ADDENDUM NO. ONE

JOB NAME: Shoals Library Expansion

PROJECT NUMBER: 23-700-121-1

DATE OF ADDENDUM: 07/30/2024

1 FIRST FLOOR LIGHTING PLAN
E210 1/4" = 1'-0"

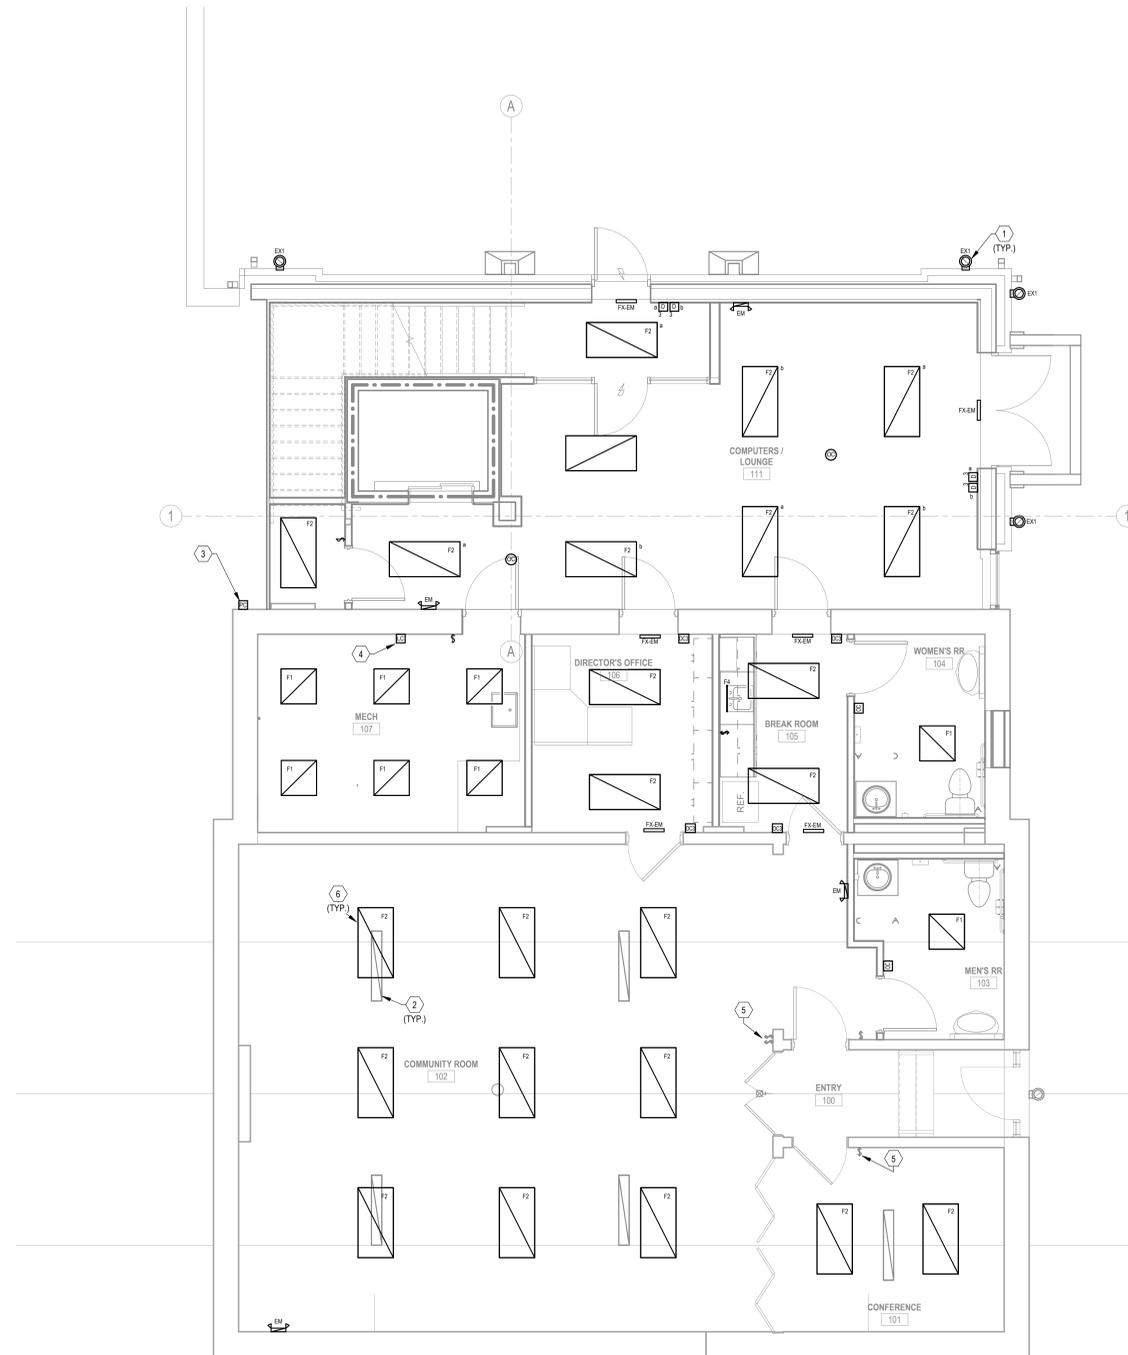
- a. This has been clarified in this addendum.
8. Note 5 on E210 says "<varies>."
 - a. This has been addressed in this addendum.
9. AD102 is missing. Please confirm if this is supposed to be included.

1. G-000 – Cover Sheet:
 - a. Added Sheet AD102.
 - b. Removed Fire Protection Sheets.
2. C100 – Site Development Plan:
 - a. Cistern to be demolished.
3. AD101 – Demo Plans
 - a. Note clarified.
4. AD102 – Demolition Photos and Notes
 - a. Sheet added.
5. AF102 – Second Floor Plan
 - a. Note clarified.
6. AC102 – Second Floor Ceiling Plan
 - a. Note clarified.
7. IN102 – Second Floor Finish Plan
 - a. Note added.
8. E210 – First Floor Lighting Plan
 - a. Note clarified.

#	NOTE
1	ALL EXTERIOR LIGHTING TO BE APPROVED BY OWNER PRIOR TO PURCHASE.
2	ALTERNATE BID: ALL EXISTING LIGHTING IN EXISTING AREA TO BE REMOVED. REPLACE WITH NEW LED LIGHTING.
3	PHOTOCELL FOR EXTERIOR LIGHTING. MAKE CONNECTION WITH EXTERIOR LIGHTING RELAY CONTROL PANEL.
4	REPLACE EXISTING TOGGLE SWITCHES WITH OCCUPANCY SENSOR WITH DIMMER TYPE.
5	ALTERNATE BID: NEW SURFACE MOUNTED LIGHTING IN EXISTING AREA.
6	EXISTING LIGHT SWITCHES SHALL BE REPLACED WITH OCCUPANCY DIMMER TYPE SWITCHES. SEPARATE MAIN AREA LIGHTING INTO 2 BANKS.
